TOWN OF GRAFTON, VT CAMBRIDGEPORT BRIDGE

PROPOSED IMPROVEMENT BRIDGE PROJECT COUNTY OF WINDHAM VT ROUTE 121, BRIDGE NO. 16G

RECORD PLANS	
CONTRACTOR:	F.W. WHITCOMB CONSTRUCTION CORP. - WALPOLE, NH
RESIDENT ENGINEER:	CHAD GREENWOOD
CONSTRUCTION BEGAN:	APRIL 11, 2006
CONSTRUCTION COMPLETE:	MAY 11, 2007
RECORD PLANS BY:	CHAD GREENWOOD & AMOS KEMPTON
I HEREBY CERTIFY THAT ALL THE CONSTRUCTION REQUIRED BY THIS SET OF DRAWINGS HAS BEEN ACCOMPLISHED AS INDICATED HEREIN.	
BY:	RESIDENT ENGINEER
DATE:	1/23/12
NOTE: Any further information concerning final quantities, amounts or other details relative to this project may be found at Central Files in the electronic archives.

THIS SHEET SUPERSEDES CONTRACT PLAN SHEET 1 DATED 6/05. REVISIONS ON THIS SHEET REFLECT CHANGES IN DESIGN AND DETAILS AS PER CHANGE ORDER NO. 2, SUBSTITUTING NEW STEEL BEAMS FOR RECYCLED BEAMS.

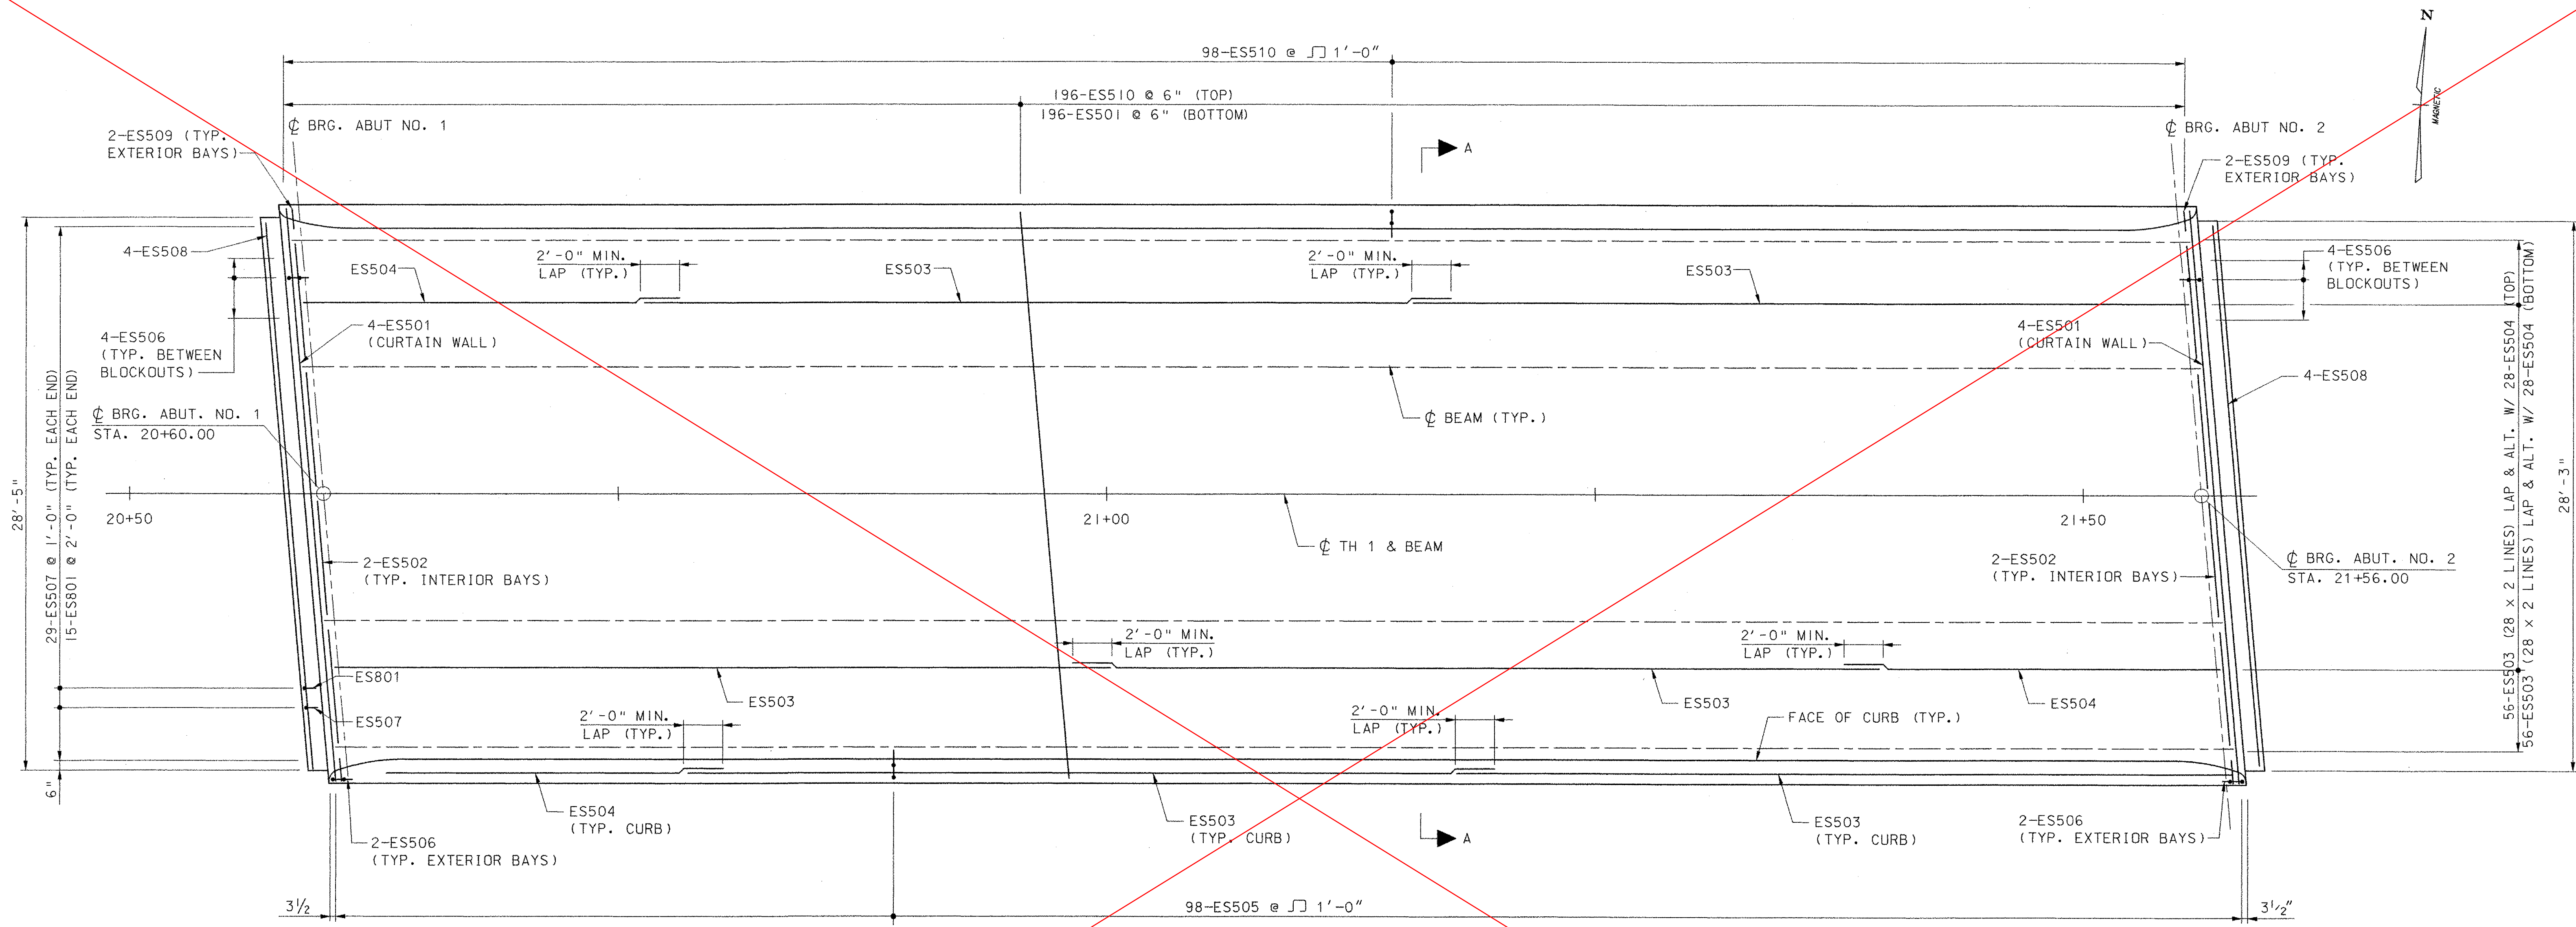
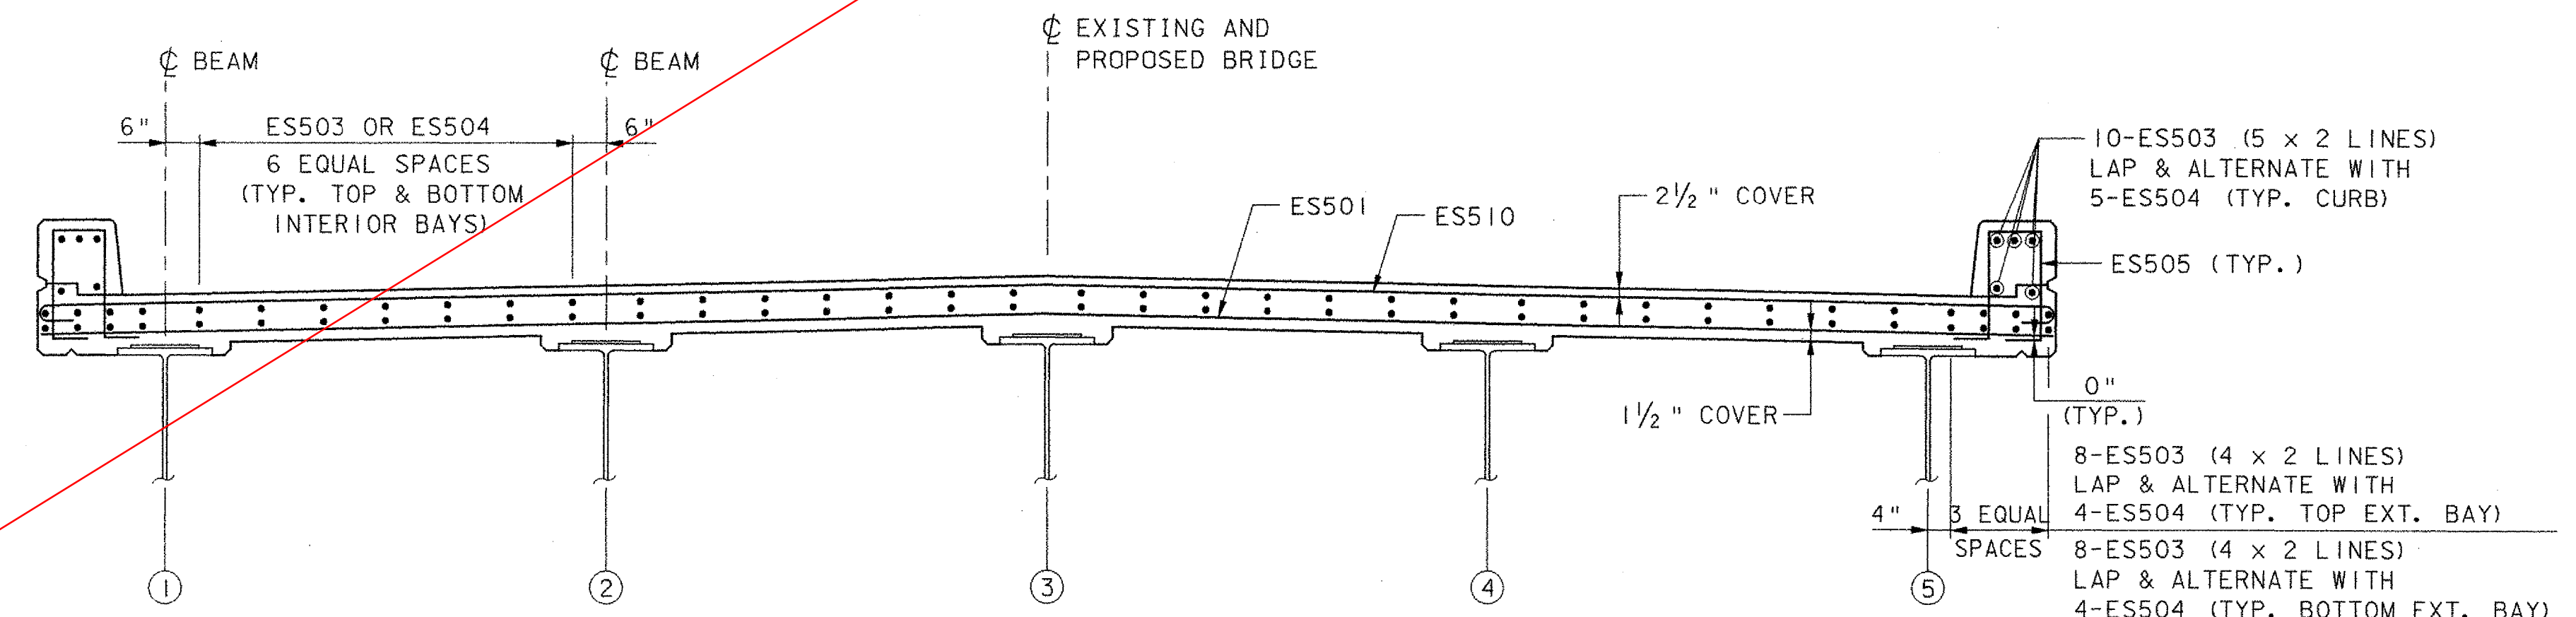
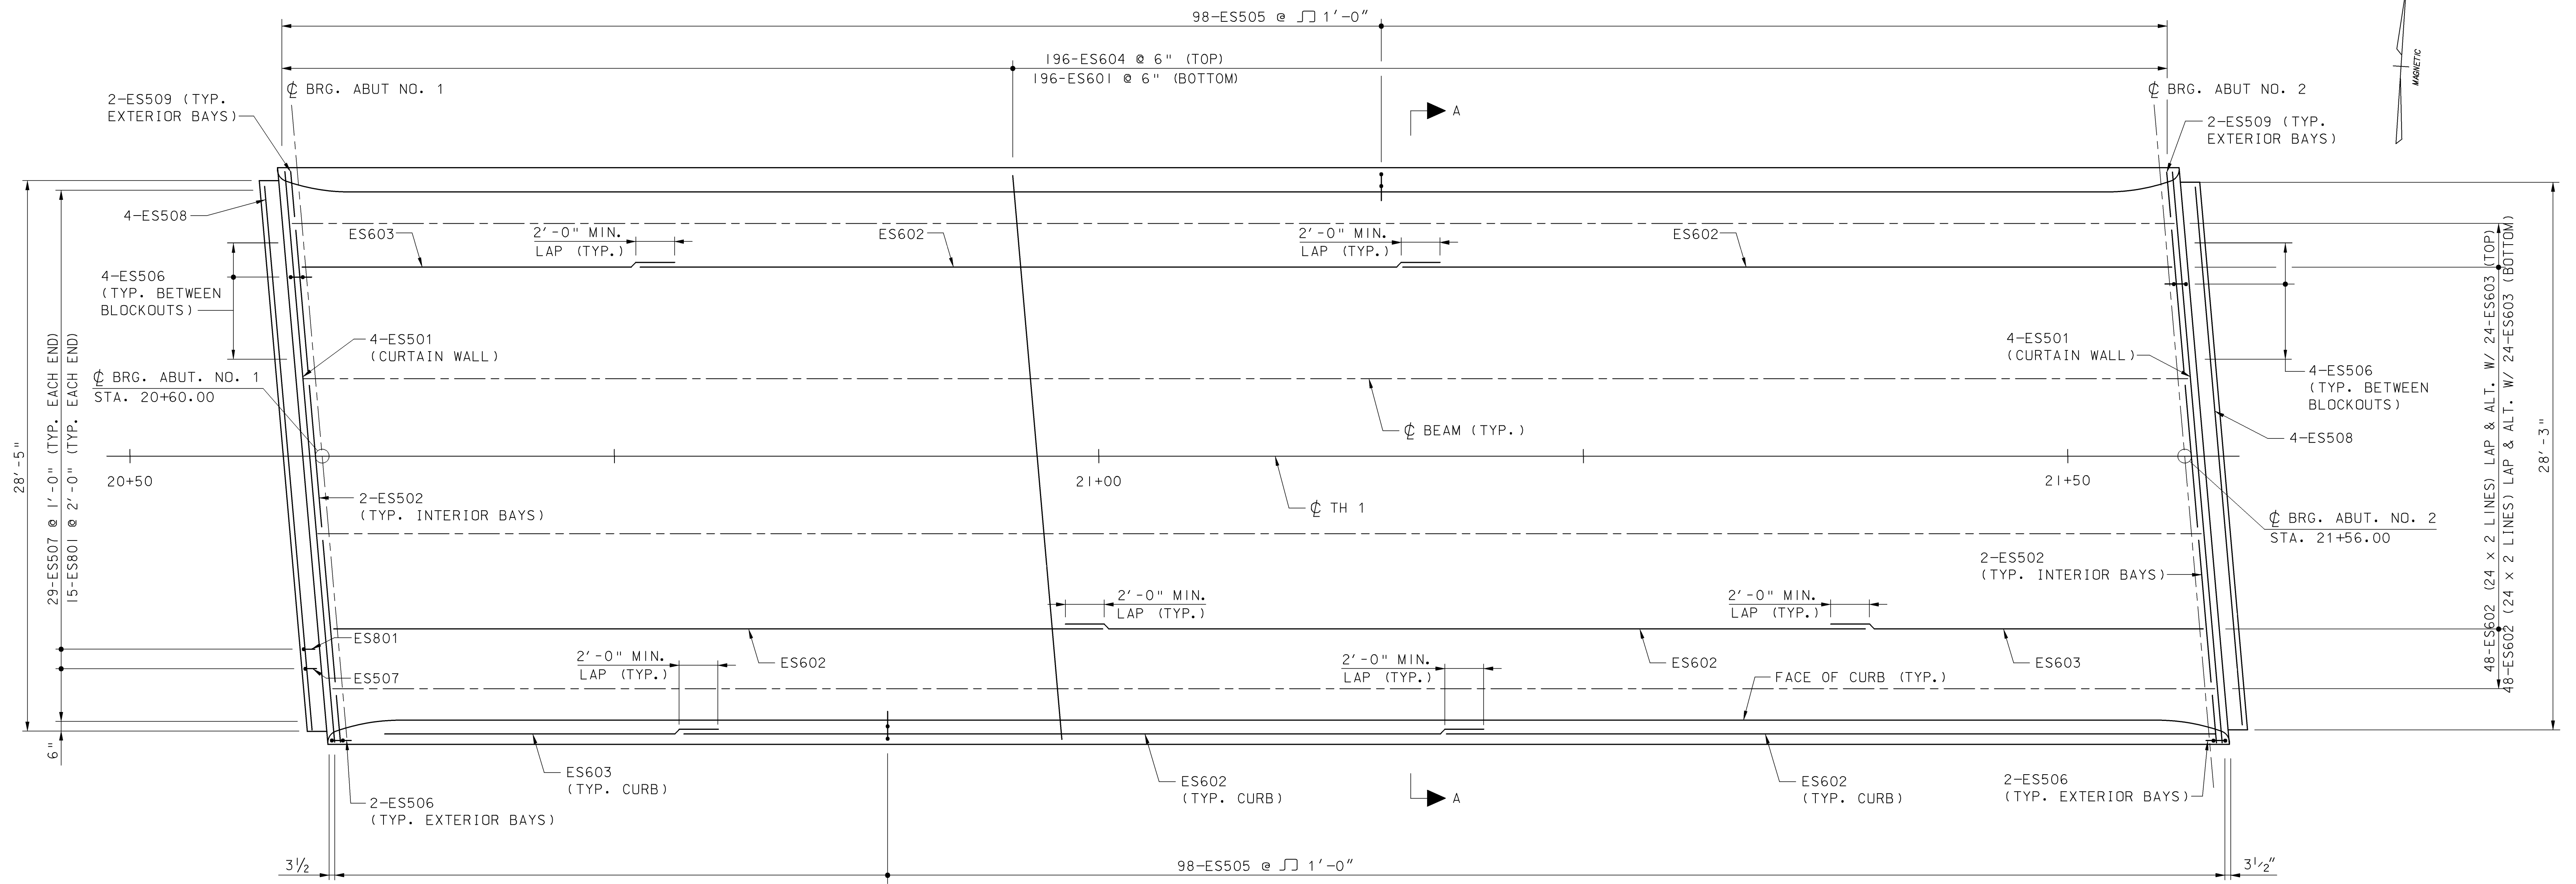
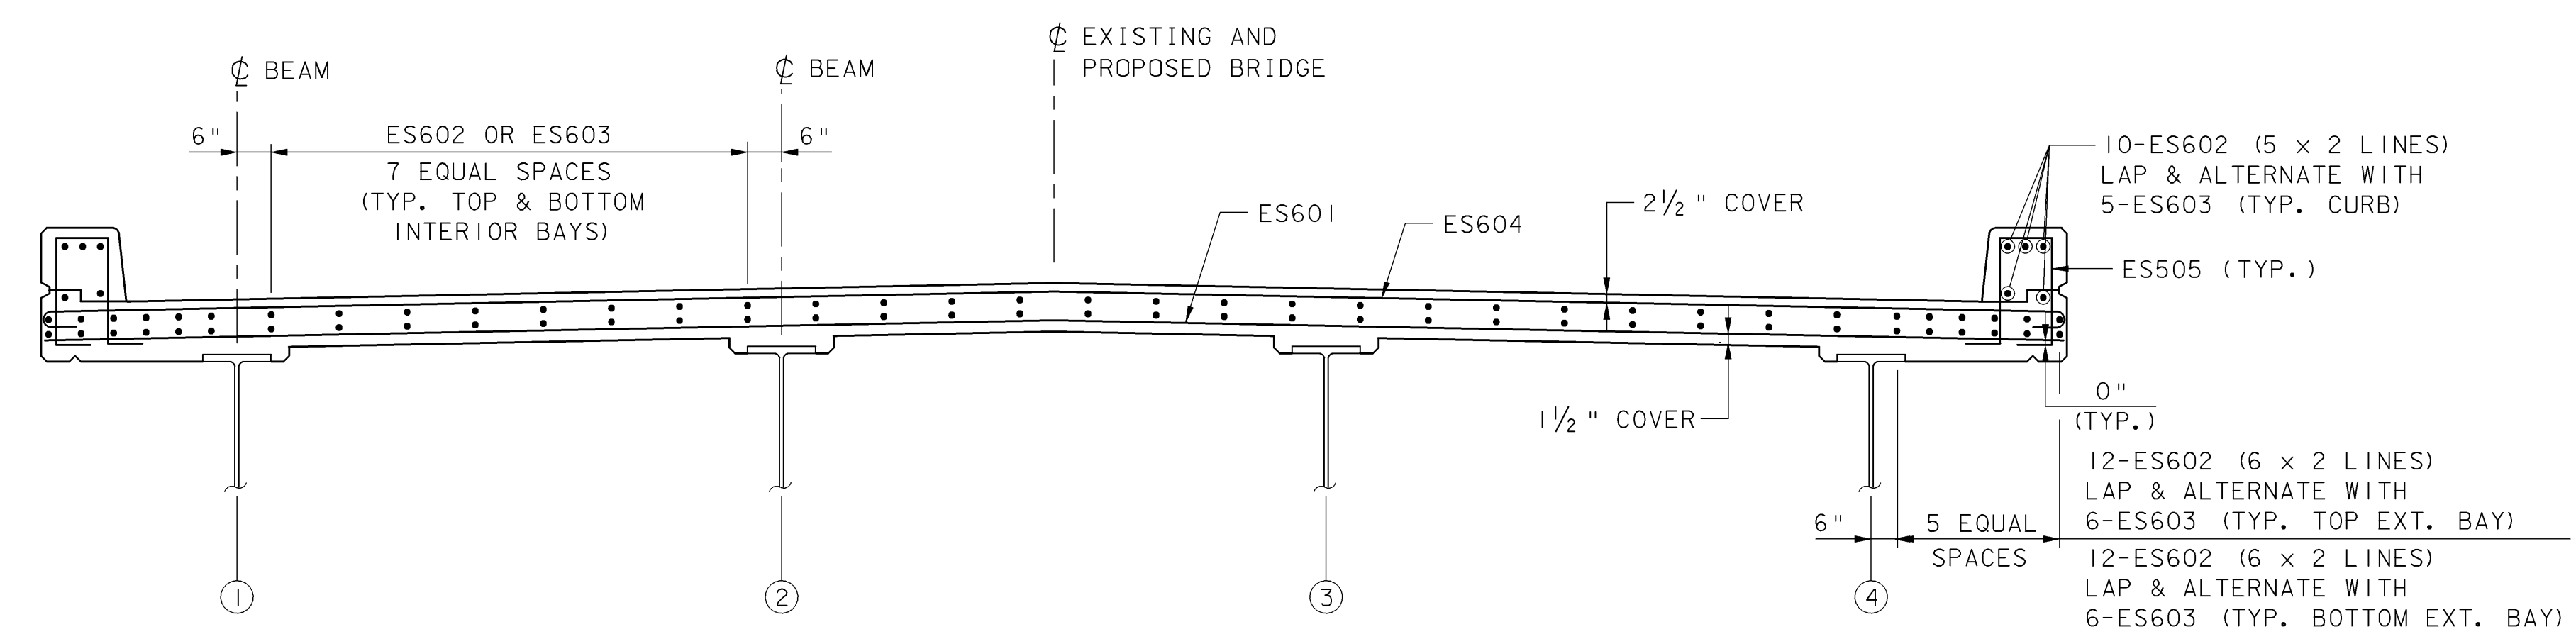
THIS SHEET SUPERSEDES CONTRACT PLAN SHEET 28 DATED 6/05. REVISIONS ON THIS SHEET REFLECT CHANGES IN DESIGN AND DETAILS AS PER CHANGE ORDER NO. 2. SUBSTITUTING NEW STEEL BEAMS FOR RECYCLED BEAMS.
